ALAMEDA COUNTY
HEALTH CARE SERVICE AGENCY
REBECCA GEBHART, Interim Agency Director

Subject: Conditional Work Plan Addendum Approval for Fuel Leak Case RO0002935 and GeoTracker Global ID T0619748201 Automasters, 6200 Shattuck Avenue, Oakland, CA 94609-1237

A Attachment 2 Conference Call Proposed Boring Locations Fig. 6

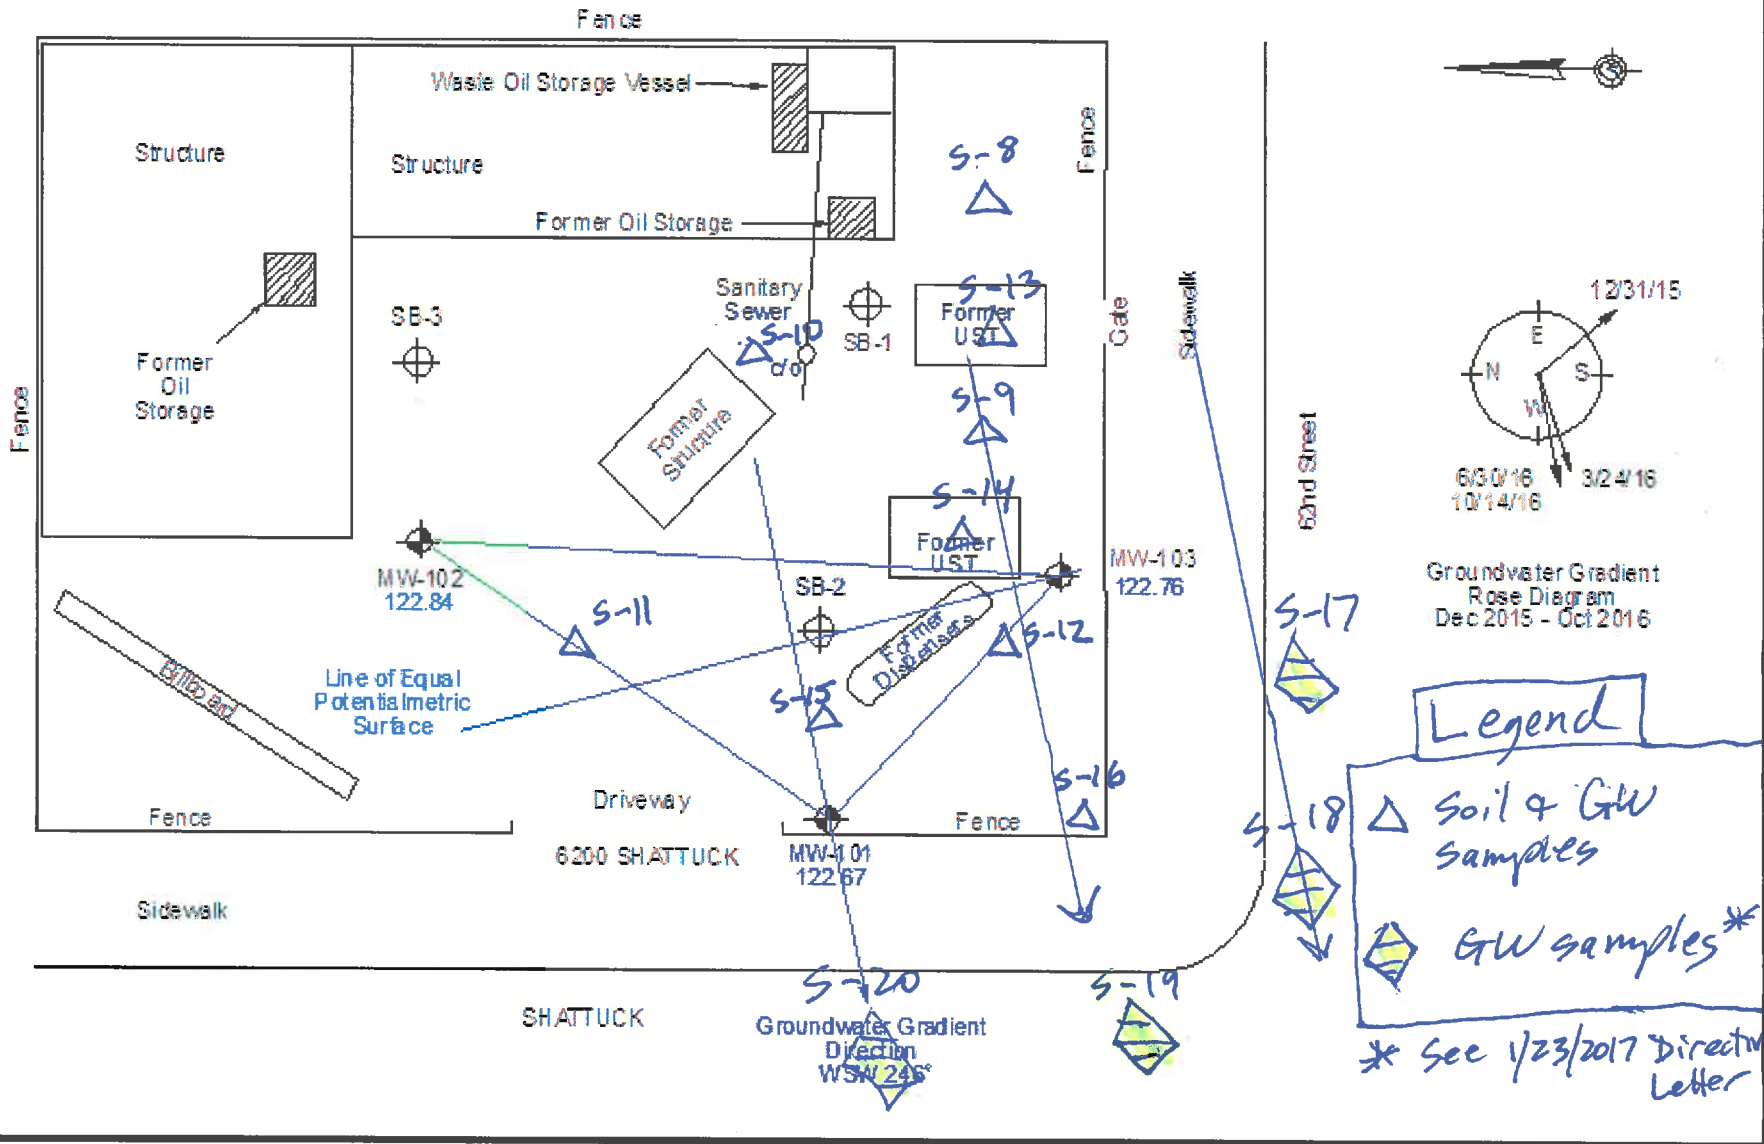
- Suggested Soil Boring Locations:** During our conference call, we reviewed Figure 6 of the Addendum and suggested relocation of several proposed soil borings to better satisfy the LTCP data gaps. The suggested locations are shown on the attached *Conference Call Proposed Boring Locations Figure 6* and the rationale supporting the relocation of the borings is shown in the following table. If you are in agreement with the proposed locations, please e-mail a Revised Figure 6. Upon e-mail submittal to and e-mail confirmation by ACDEH of a Revised Figure 6, the Addendum is approved for implementation. Submittal of a revised work plan or a work plan addendum is not required unless an alternate scope of work outside that described in the work plan addendum is proposed. We request that you perform the proposed work, and send us the technical data in described below. Please provide 72-hour advance written notification to this office (e-mail preferred to: karel.detterman@acgov.org) prior to the start of field activities.

Boring Designation	Change from 12/30/2016 Addendum Figure 6	Location Rationale	Suggested Sample Collection
S-8	Move slightly to east	Upgradient location of East UST	soil & groundwater
S-9	Move between two USTs	Between East & West USTs	soil & groundwater
S-10	Move near Sanitary Sewer	Cross/upgradient of East UST	soil & groundwater
S-11	Move upgradient of Dispenser Island	Cross/upgradient of Dispenser Island	soil & groundwater
S-12	No change	Downgradient of West UST and Dispenser Island	soil & groundwater
S-13	No change	Vertical definition through East UST location;	soil & groundwater
S-14	No change	Vertical definition through West UST location;	soil & groundwater
S-15	No change	Down/Cross Gradient Dispenser Island	soil & groundwater
S-16	Move to southwest corner of property	Downgradient West UST and Dispenser Island & property corner	soil & groundwater
S-17	Added location in 62 nd Street	Downgradient off site in 62 nd Street	groundwater but add soil if impacts observed

S-18	Added location in 62 nd Street	Downgradient off site in 62 nd Street	groundwater but add soil if impacts observed
S-19	Added location in Shattuck Avenue	Downgradient off site in Shattuck Avenue	groundwater but add soil if impacts observed
S-20	Added location in Shattuck Avenue	Downgradient off site in Shattuck Avenue	groundwater but add soil if impacts observed
